R. R. Sgarro
Manager, Nuclear Regulatory Affairs

**BELL BEND NUCLEAR POWER PLANT
RESPONSE TO ENVIRONMENTAL
REQUESTS FOR ADDITIONAL
INFORMATION, FIFTH SUBMITTAL
BNP-2009-282 Docket No. 52-039**

Responses to Environmental Requests for Additional Information
Bell Bend Nuclear Power Plant
Luzerne County Pennsylvania

Figure 1

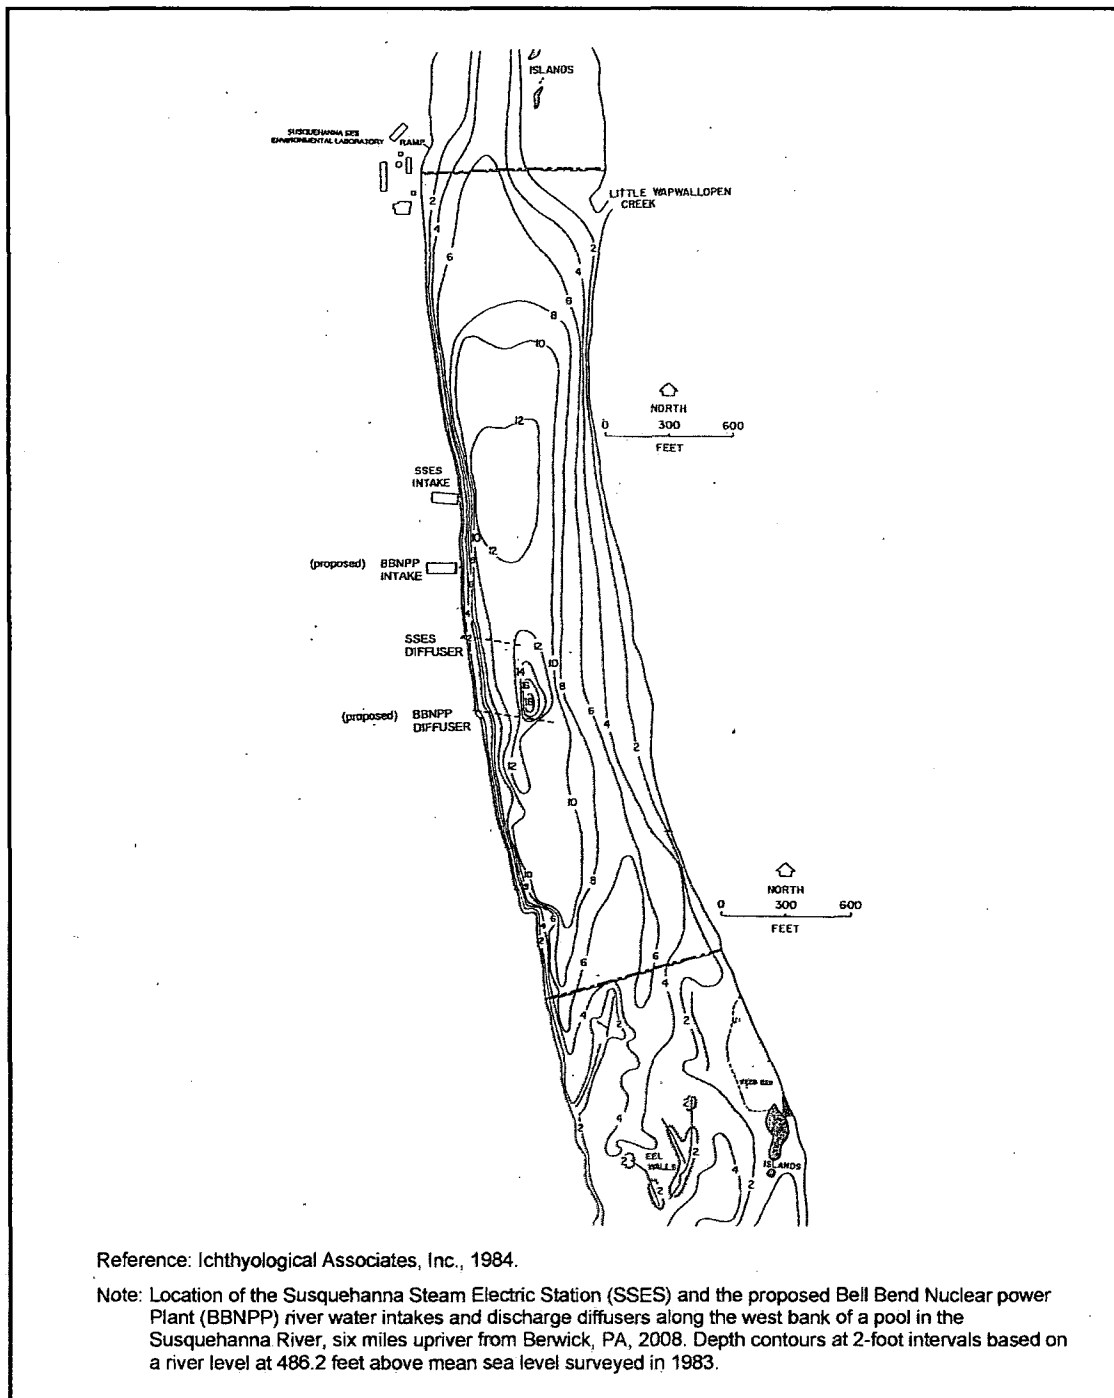
Summary: *Provide correct water depth (as feet below a standard reference point) at the intake and discharge areas in the Susquehanna River.*

Full Text: The bathymetry of the Susquehanna River is provided as feet above mean sea level. The text indicates that the riverbed elevations near the intake range from 473 to 484 ft. Figure 2.3-11 shows the contour range at the intake site to be from 476 to 490 ft. The 473 ft contour is a small area about 200 ft south of the proposed intake site. The depth of the discharge listed in Ch. 3 differs from that in Ch. 2.

Response: Ichthyological Associates' report provides a figure (Figure 1) showing the depth contours in the vicinity of the intake and discharges structures. Depth contours are based on a river level at 486.2 ft above mean sea level (msl) surveyed in 1983. Figure 1 follows.

**FIGURE 1-1
LANDFILLS IN PA WITH CAPACITY FOR 3.5 MILLION CUBIC YARDS**

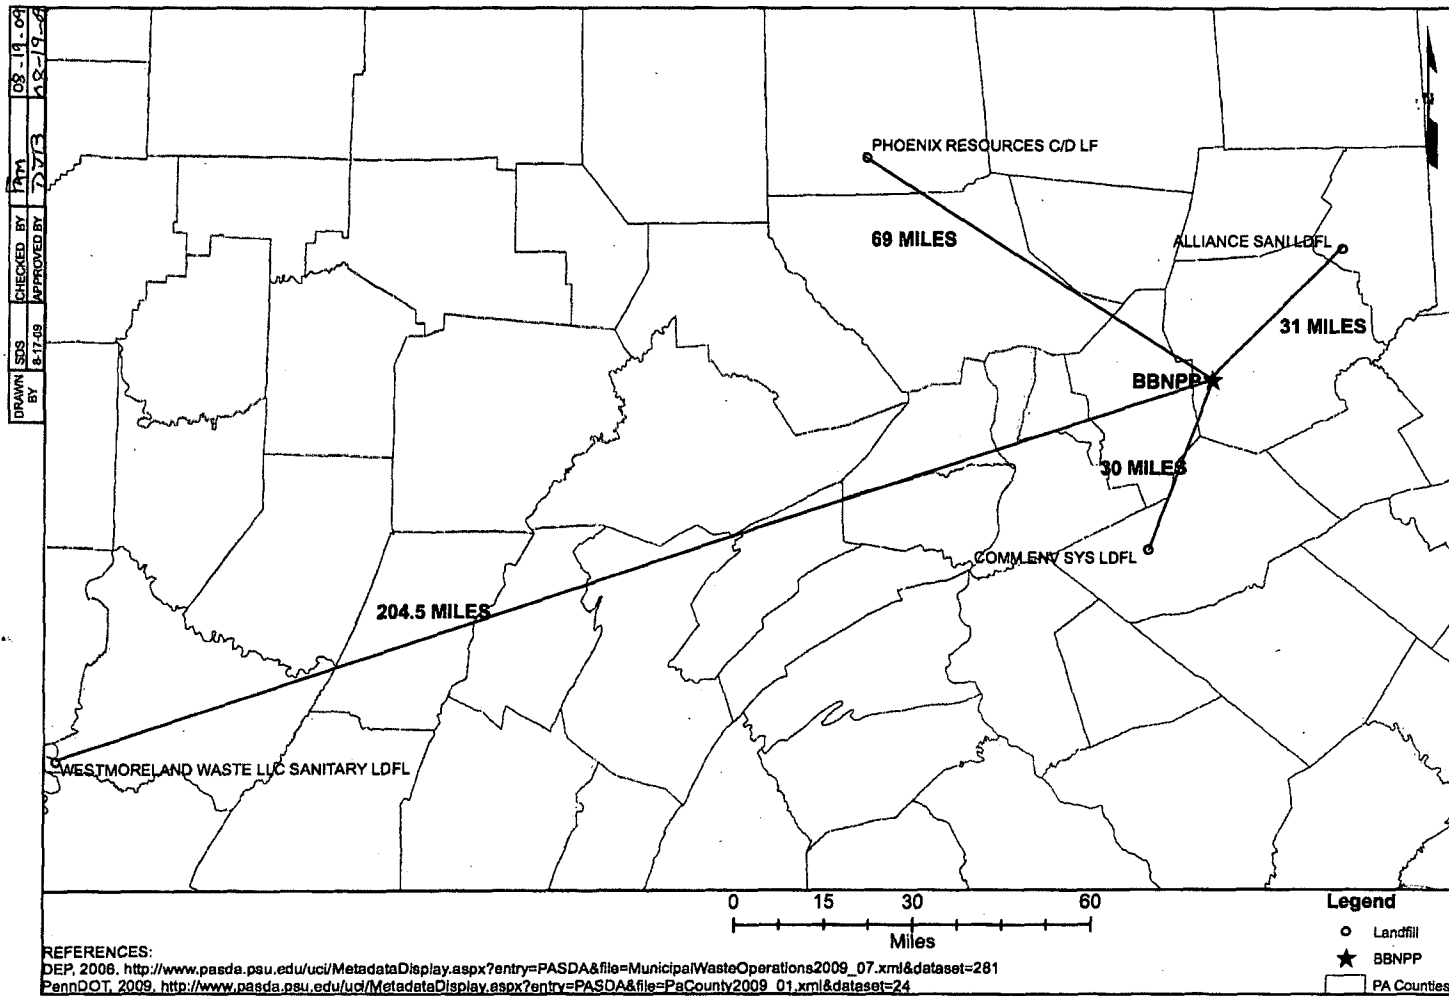
Summary: *Provide the location of the disposal site for excess excavated material (soils), the planned routes for transporting the excess material and any upgrades necessary for these routes, and any planned measures for erosion control and stabilization of the disposal site at project completion.*

Response: Location: Figure 1-1 is attached which shows four existing solid waste disposal areas, each of which can take over 3.5 million cubic yards of waste material. The landfills shown are:

Transportation: The landfills shown on Figure 1-1 are existing, and public roads lead to each of the sites. The spoils materials from the site will be transported on existing public roads to the landfill or landfills used. Upgrades or maintenance of the roads to each site would be decided by a state or local agency. The locations and route to each landfill are:

FIGURE 3.4-3

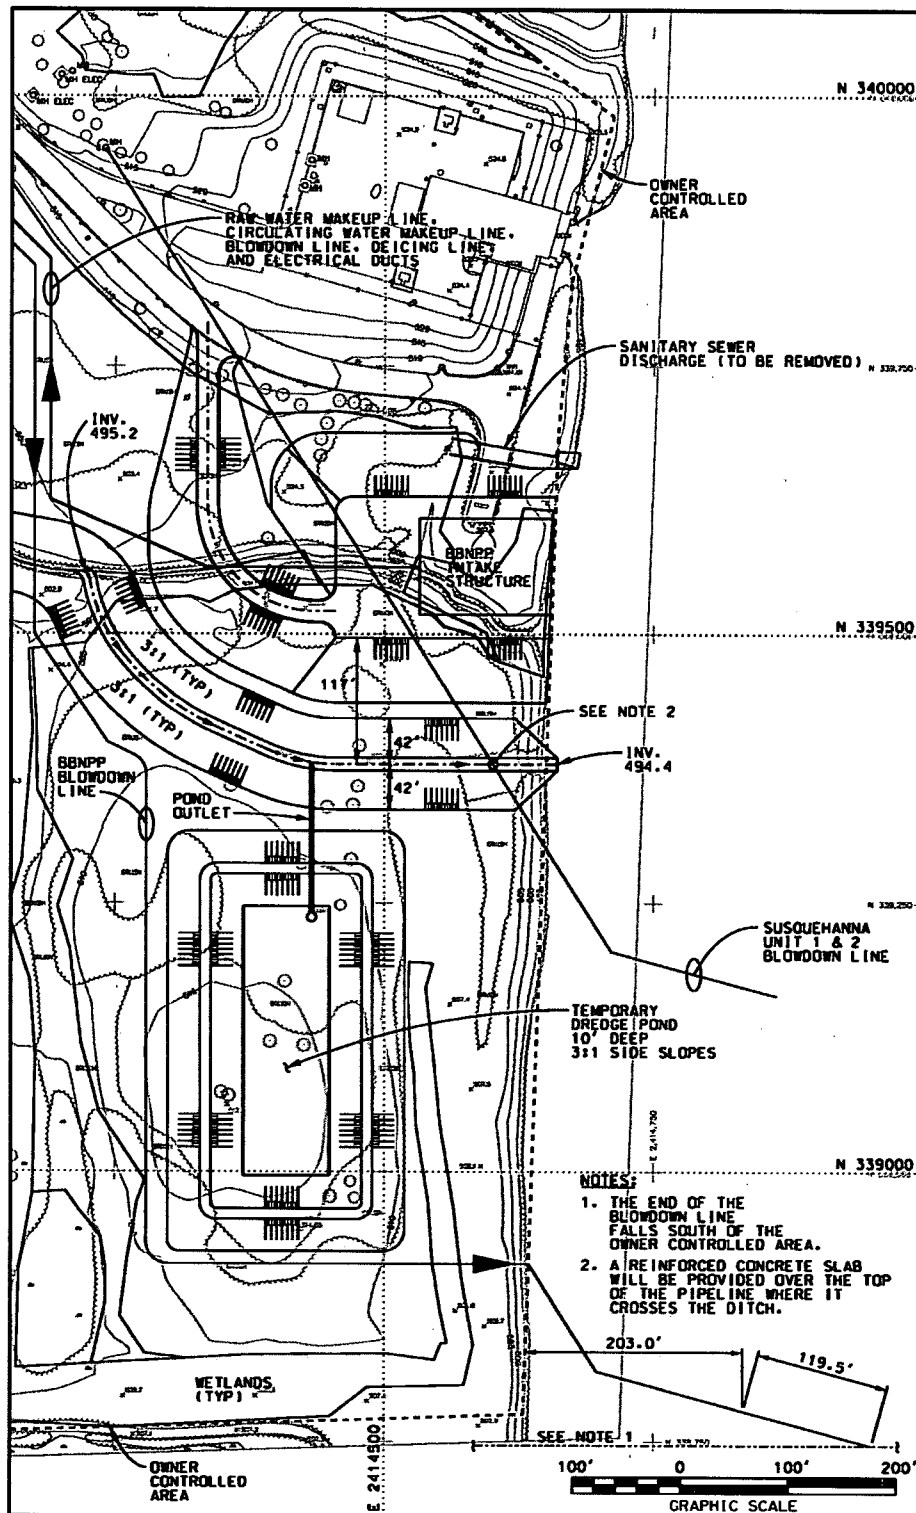
Summary: *Provide a figure showing the locations proposed for storage of dredge and fill materials.*

Response: Figure 3.4-3 is provided to show a temporary dredge pond. Dredge spoils are pumped into the pond, the spoils settle out, and the excess water drained off and discharged back to the river. The water will meet the requirements of the PaDEP before being released. After the dredging is completed, the entire dredge pond will be removed, and the pond and dredge spoils hauled to a solid waste disposal area. The temporary dredge pond area will be returned back to its original state.

**FIGURE 1-1
LANDFILLS IN PA WITH CAPACITY FOR 3.5 MILLION CUBIC YARDS**

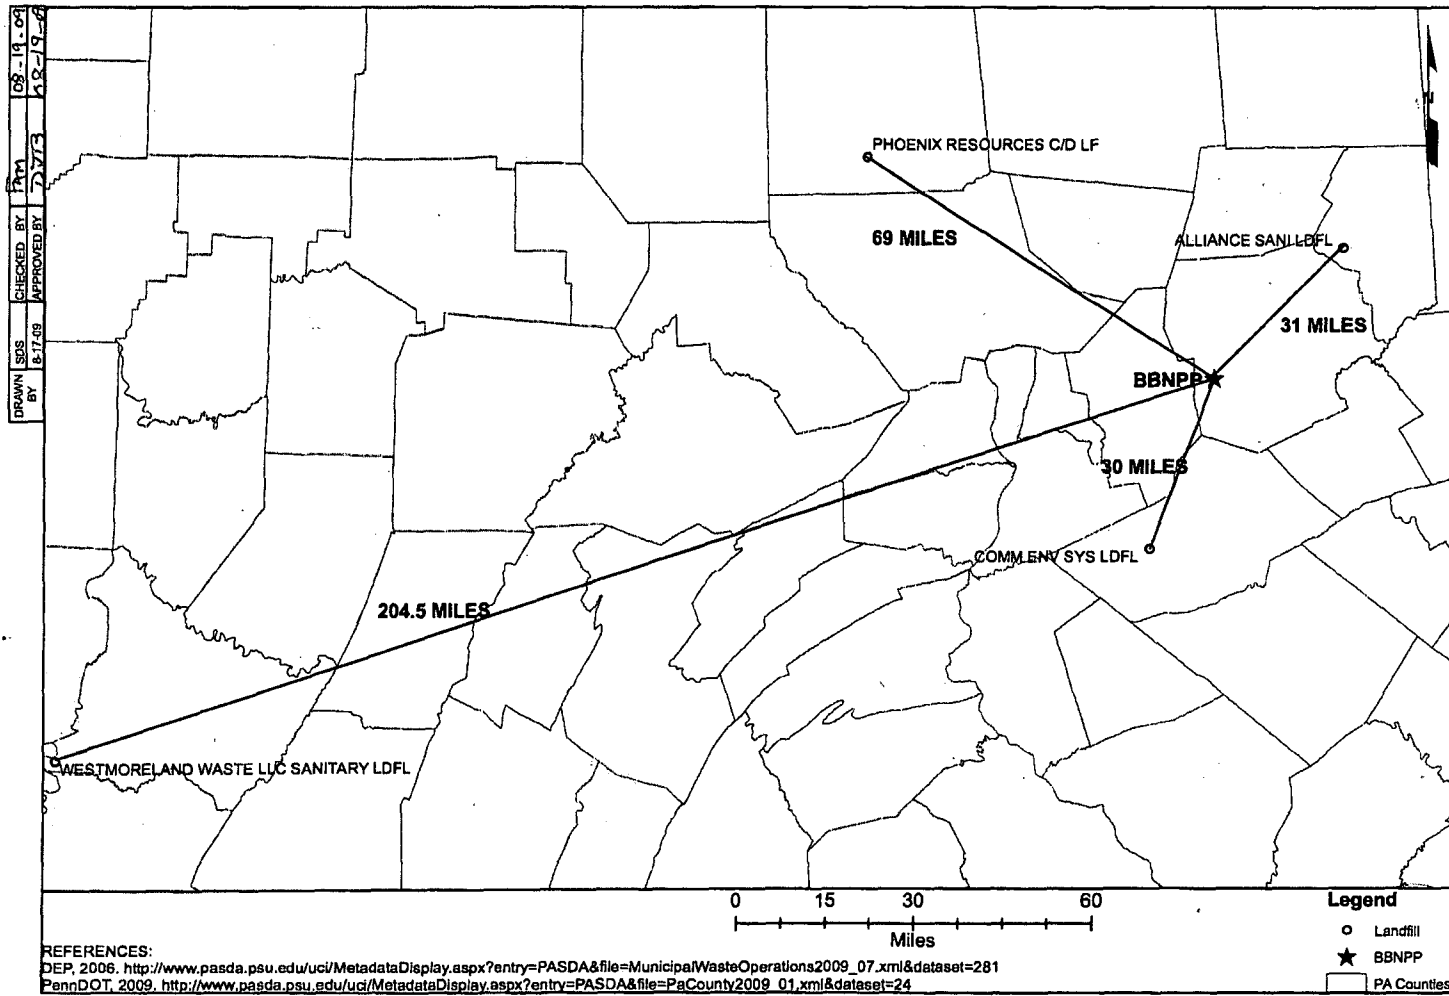
Summary: *Provide a vicinity map and plan for the disposal options for any excess fill material resulting from construction.*

Response: Location: Figure 1-1 is attached and shows four existing solid waste disposal areas, each of which can take over 3.5 million cubic yards of waste material. The landfills shown are:
